SERVICE BULLETIN

APPLICABILITY: 2020MY Legacy and Outback **NUMBER:** 07-189-21
SUBJECT: Front Door Window Regulator- Erratic Operation **DATE:** 02/15/21

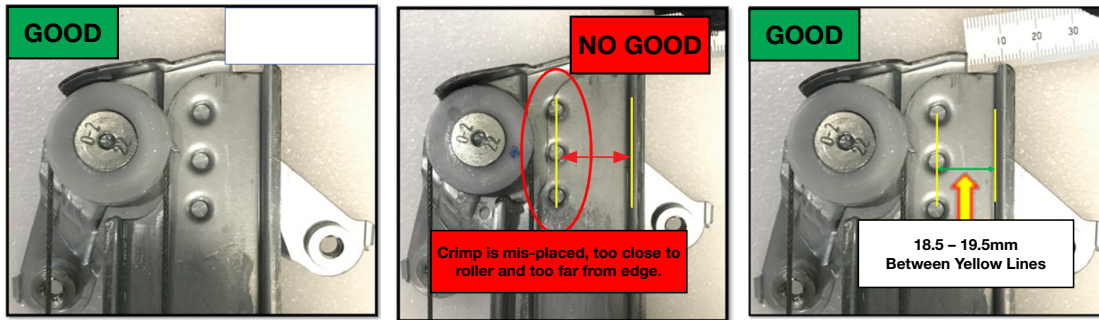
STEP 2: Measure the regulator upper roller frame to confirm the crimping process was performed in the proper location as shown in the comparison photos below. If the crimp is out of position, the window regulator assembly must be replaced.

- In the NO GOOD photo above, the crimp tool edge has contacted the 3 “dimples” and the gap between them and the edge shown in the “GOOD” photos is exceeds 19.5mm. If EITHER of these conditions is identified, the window regulator assembly must be replaced.
